C-4-15(c), LILLIE KREYNUS, ET AL.

Commercial Rezoning Report
Henry Magisterial District
PC Meeting Date: July 16, 2015

KROGER MARKETPLACE R-529
HANOVER COUNTY, VIRGINIA
FOR
KROGER MID-ATLANTIC
P.O. BOX 14602, ROANOKE, VA 24038
(540) 563-3645

Kroger Store R529

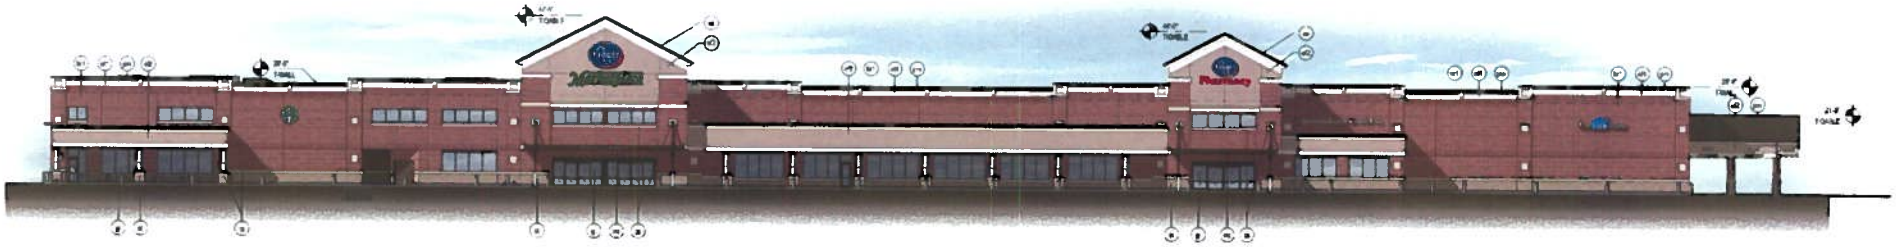
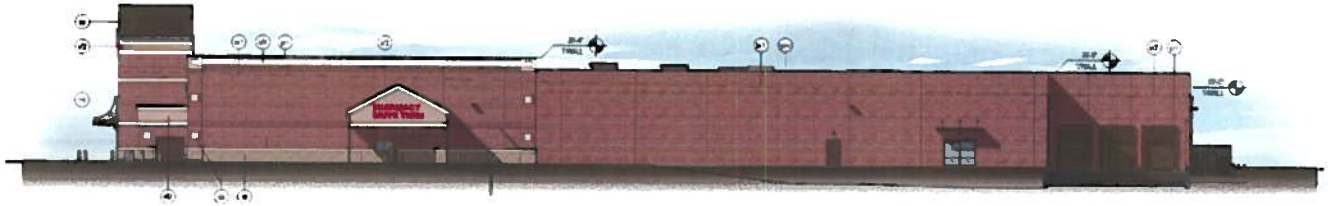
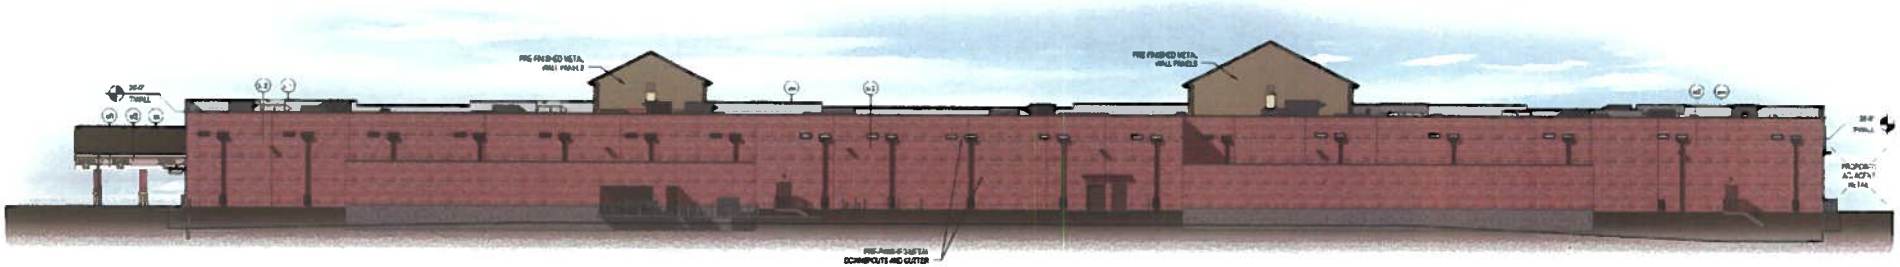
Elevations of the Kroger store and fuel center have been provided that show that quality materials are proposed, including brick, cast brick, stone, cast stone, integrally colored split-faced block, dryvit, other simulated stucco, and glass, with roofing primarily standing seam metal where visible. The proposed front materials are carried around the entire structure. The elevations submitted have been proffered and are attached.

2. Architecture. **Do not accept**. The applicant has proffered *general* conformity to the elevations for the Kroger store and fuel center and staff recommends *substantial* conformity to the elevations. The remaining provisions of this proffer are acceptable as it states that the property will be developed with a unified and complementary color and architectural theme, but allow retail tenants to include prototypical or corporate identification elements in the design of their space. Standards of compatibility are stated and the Director of Planning is identified as the entity conducting reviews of proposed structures.

SHEET NUMBER
C-1.3

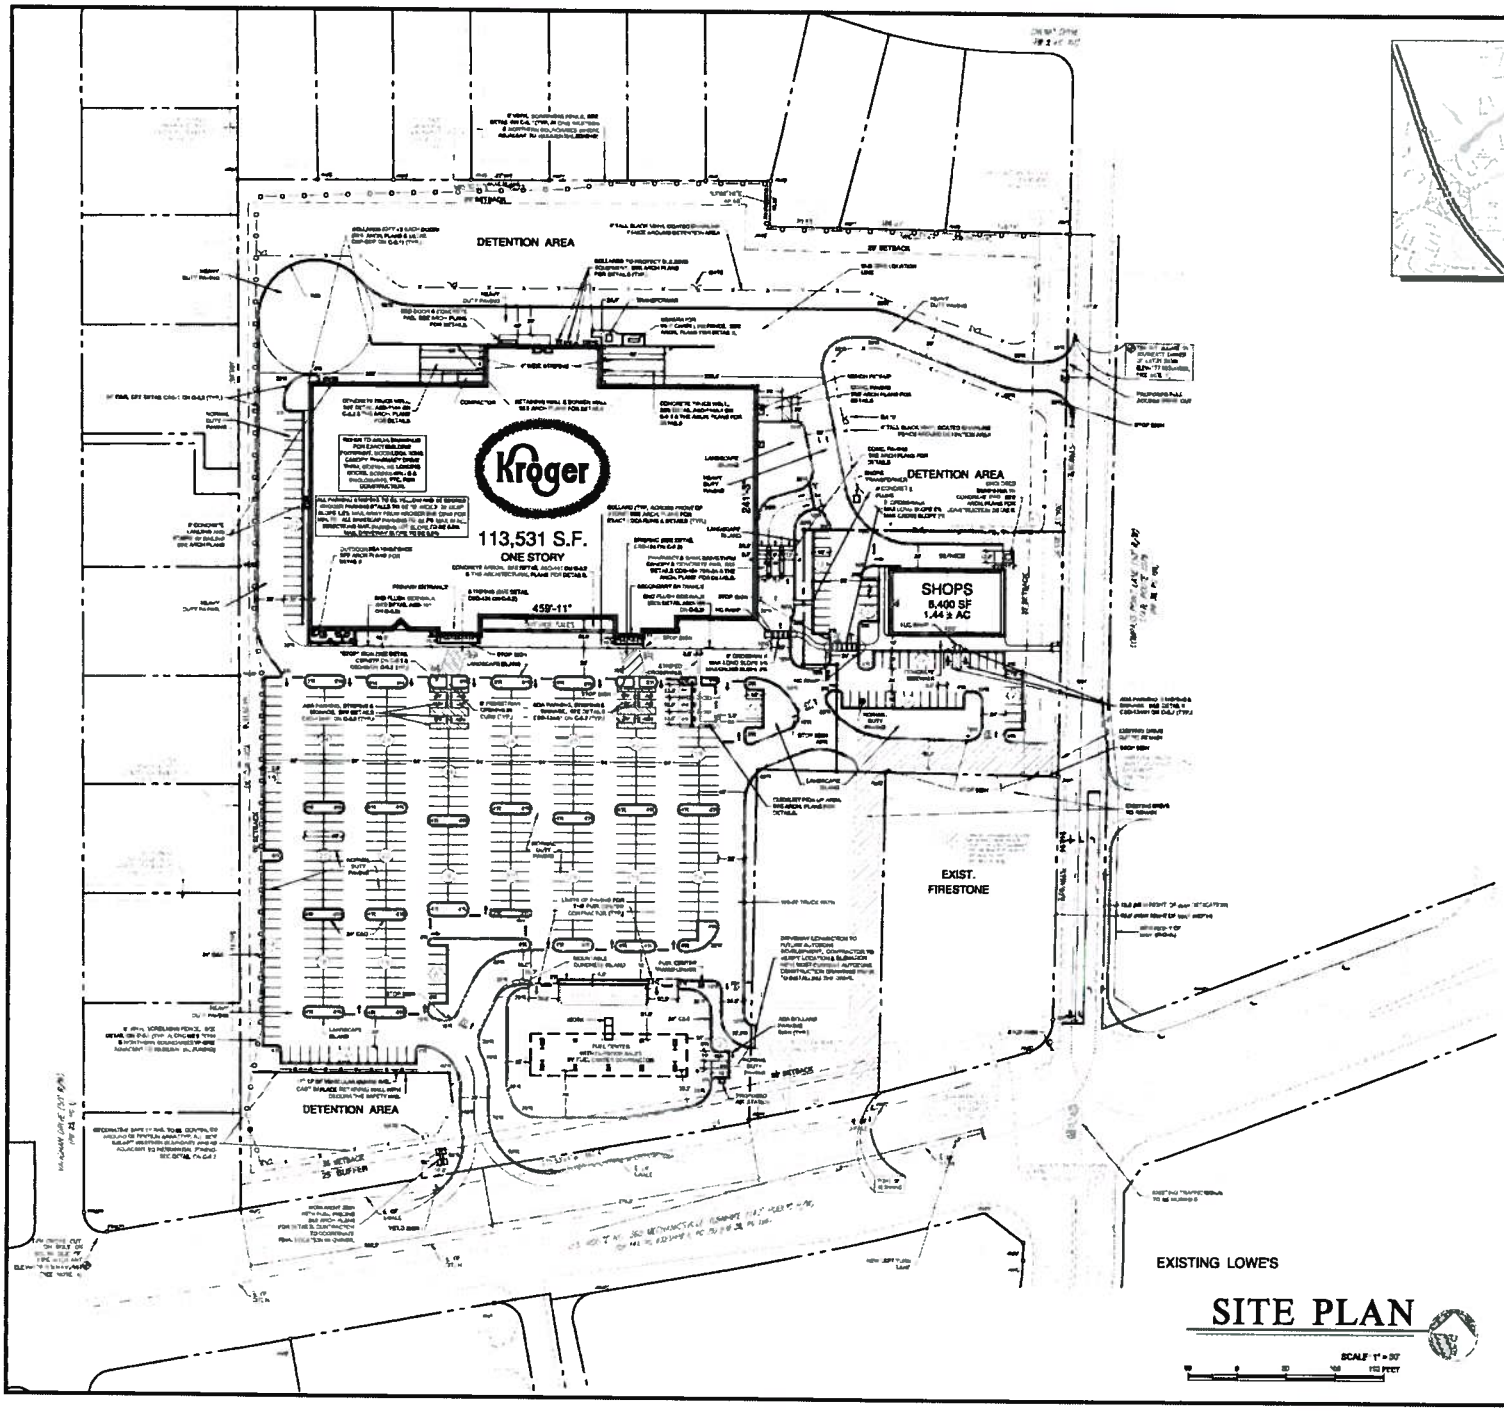
The conceptual plan submitted has addressed most of the site design requirements of the Zoning Ordinance and provides features to remediate the development's impacts on adjacent parcels. Staff has identified several issues that must be addressed to meet all design requirements and functionality of the site. Those include:

1. 510 parking spaces are required for the property (1 per 250 s.f. for first 100,000 s.f. plus 1 per 200 s.f. for remainder). The Plan shows 486 spaces, which means 24 more spaces are required. The 486 spaces include 3 spaces for the ClickList pick-ups. Also, no cart corrals have been shown on the plan. Cart corrals cannot be located in required parking spaces.

2. The Checklist pick-up station is a new concept for Hanover grocery stores; therefore, how it will function with traffic circulation is unknown. Staff has concerns about the location in close proximity to the main entry area into the parking lot, which is near the pharmacy drive through.
3. The label for the drive-through lanes should be corrected (a bank drive-through is not actually proposed).
4. All parking islands must be at least 6' wide. There is one island near the fuel pumps that appears to be only 5' wide.
5. VDOT will require an extension of the transition lane on Compass Point Drive north of the left turn lane drop at the first entrance on that road. Those details are provided below with the discussion of all other roadway improvements.

In addition to the VDOT planned projects in this area and those proffered by the applicant for the subject site, VDOT has reviewed the latest conceptual plan and notes that a proper transition from the proposed roadway improvements on Compass Point Lane must be constructed. Currently, the conceptual plan shows a left turn lane at the first entrance that was created from the current through lane and a through lane has been added to Compass Point Lane; however, the left turn lane stops at this entrance and the new through lane quickly merges into the existing roadway. VDOT states that the transition of the new through lane past the left turn back into the existing road must be 175 feet, if speed limit on Compass Point is 25 mph, or 250 feet, if the speed limit is 35 mph. This additional improvement to Compass Point Lane should be shown on the conceptual plan and added to the list of roadway improvements to be constructed in Proffer No. 18.

1. Based on the currently proposed retail square footage, a total of 510 parking spaces are required and only 486 are shown. A revised plan must be submitted showing 510 spaces before this case can be approved by the Board of Supervisors (it should be noted if store cart corrals will be used, they cannot occupy required parking);
2. Staff recommends that the ClickList area be moved to one of the parking rows closer to the western store entrance. This recommendation may require closer scrutiny once staff has more information regarding this use from the applicant;
3. The transition for the through lane on Compass Point Lane must meet VDOT requirements and be shown on the plan;
4. Remove "bank" from the pharmacy drive through information label;
5. All parking lot islands must be at least 6 feet wide.
